Product Change Notification

Product Change Notification: PCN-22-144482 PCN Date: 05-JUL-22

Correct the nut of 1-1423696-6 bootseal from round nut to hex nut

Current 1-1423696-6 Clear boot with round nut (M11X1.0 thread)

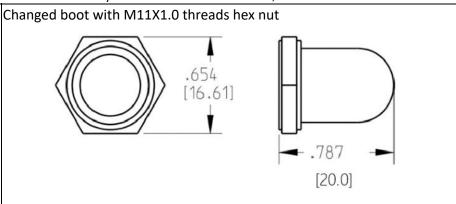
Drafting Error/Omission/Clarification, 1.TE will update the W54 and W57 datasheet for changing the nut of 1-1423696-6 bootseal from round to hex in the future; 2. TE doesn't change the thread of nut for 1-1423696-6 bootseal, it is still M11X1.0 thread, so no influence of the assembly for the 1-1423696-6 bootseal;

There is a mistake in W54 datasheet and W57 datasheet, the M11X1.0 nut of 1-1423696-6 bootseal was round in those files, but it should be M11X1.0 hex nut for 1-1423696-6

bootseal;

Correct 1-1423696-6 Clear boot with hex nut (M11X1.0 thread)
